AGENDA REPORT

SUBJECT: Appeal of Planning Commission Approval
of College Ave. Safeway Project

DATE: December 3, 2012

Safeway Shopping Center
 College and Claremont Avenue, Addendum to the EIR
 Case File Number ER09-0006

Revised Safeway Level Plan Figure 1

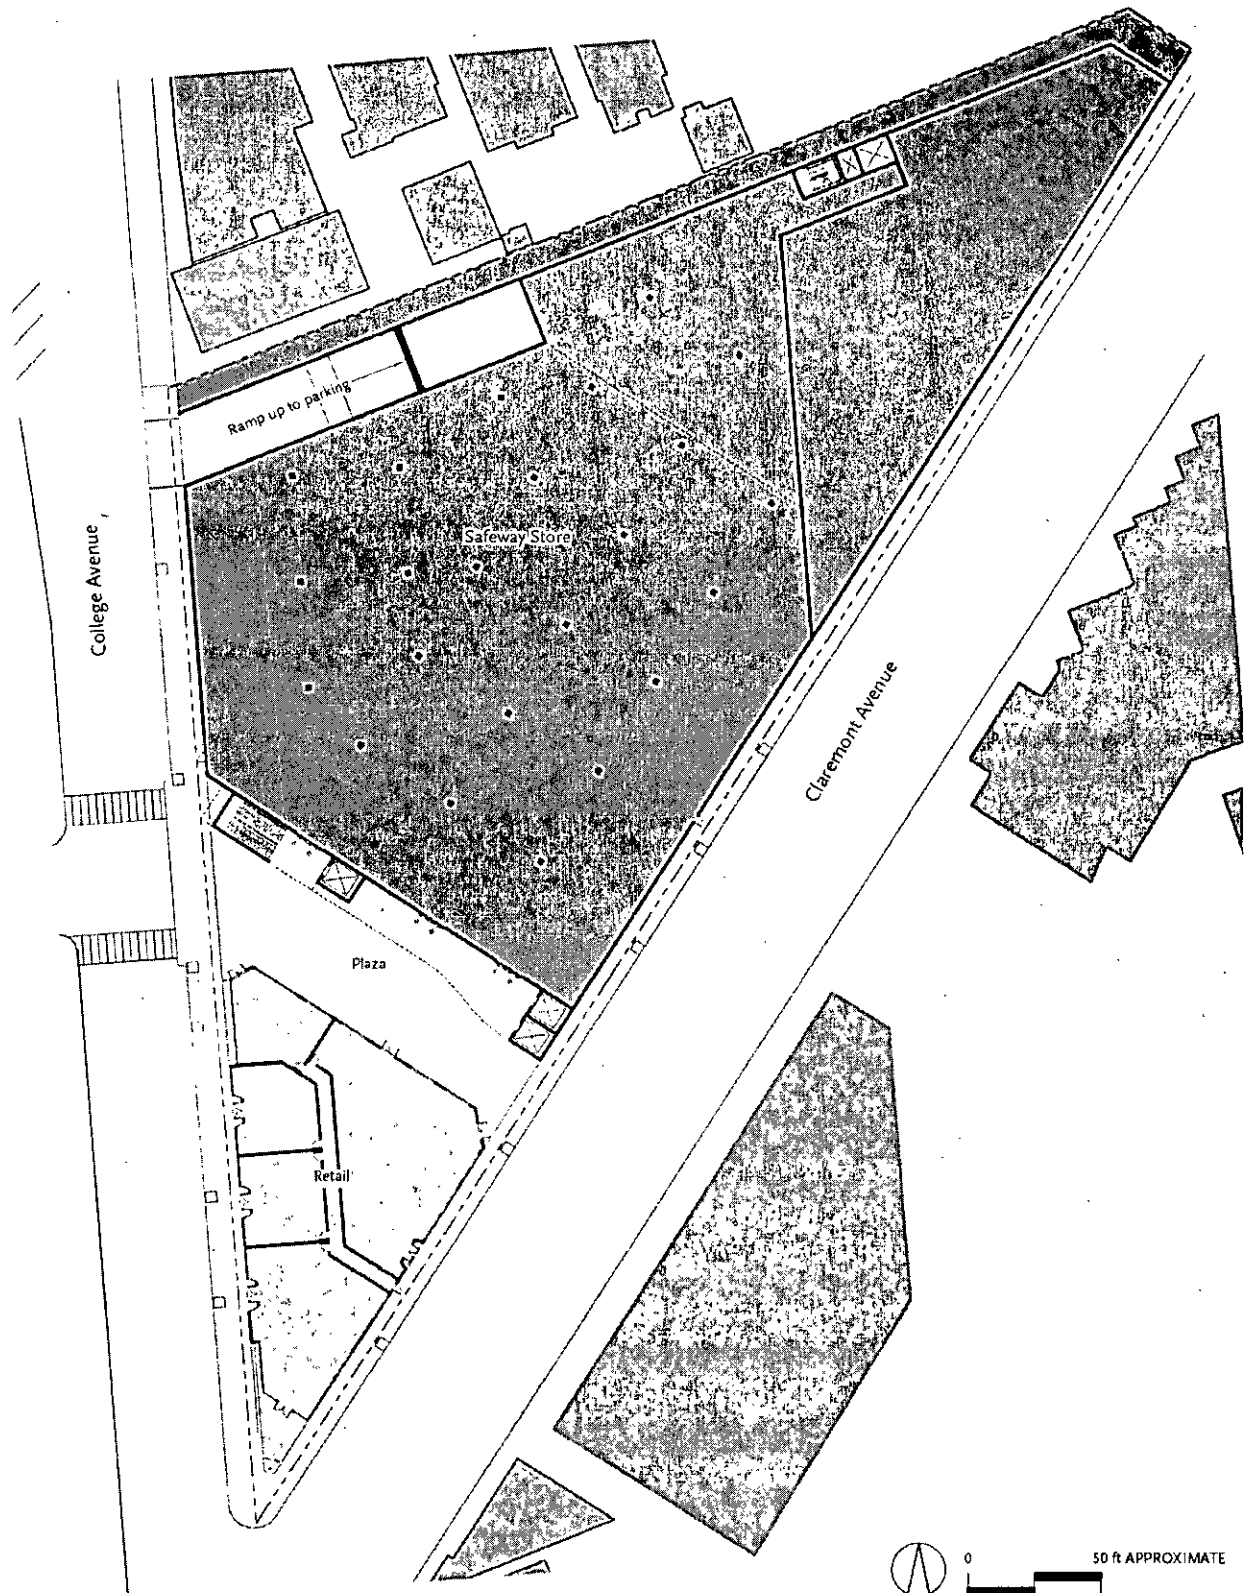
The total retail square footage of the Updated Project would be approximately 7,567 square feet (about 12 percent) smaller than that of the EIR Project. The Updated Project includes the following modifications to the EIR Project (see Figures 1 and 2):

Revised Architectural Renderings Figure 3

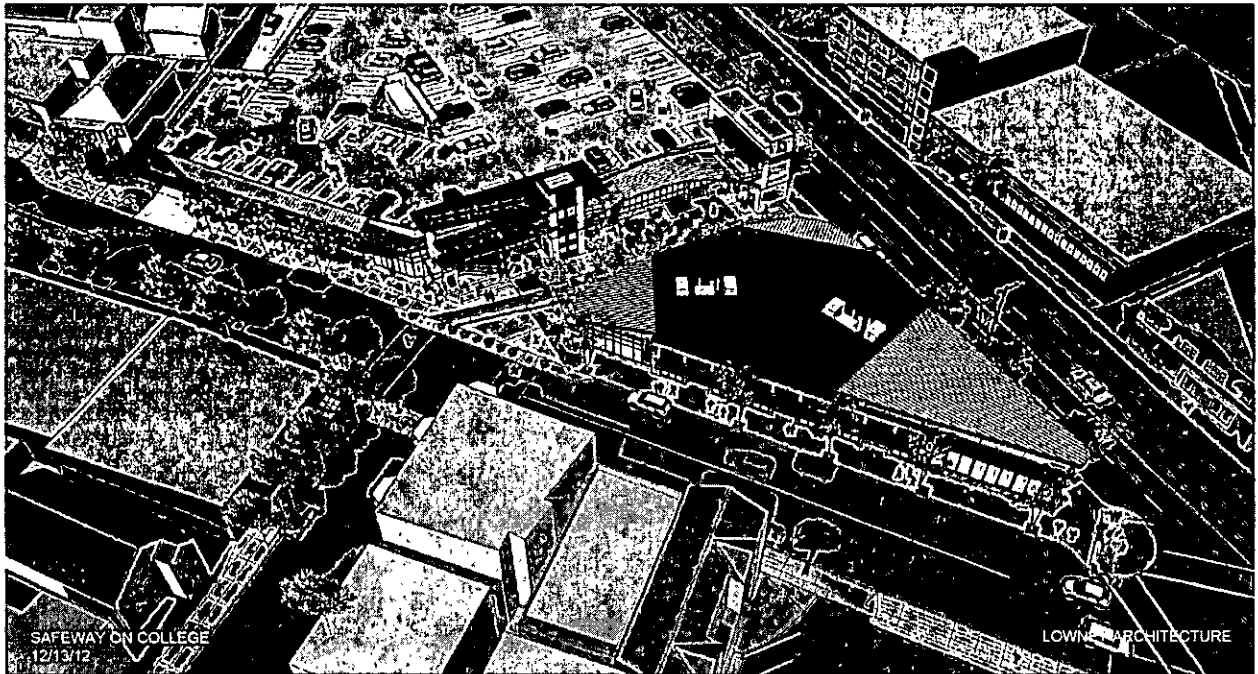
- Adjust the color scheme of the buildings to appear darker and more substantial.
- Redesign the mullions on the Safeway level of the College Avenue and Claremont Avenue façades to add louvers and provide more variation in their size and location.
- Change the material of the wall behind the restaurant on the walking street from plaster-and-wood to stone.
- Substitute stained concrete for plaster at the base of the restaurant building.
- Revise signage and lower the roofline of the store wall fronting Claremont Avenue.

In all other respects, the Updated Project would resemble the EIR Project. Project timing would remain the same. The project objectives for the Updated Project are the same as for the EIR Project. Figures 3 through 8 on the following pages show the site plan, floor plans, elevations, sections, and architectural renderings for the Updated Project.
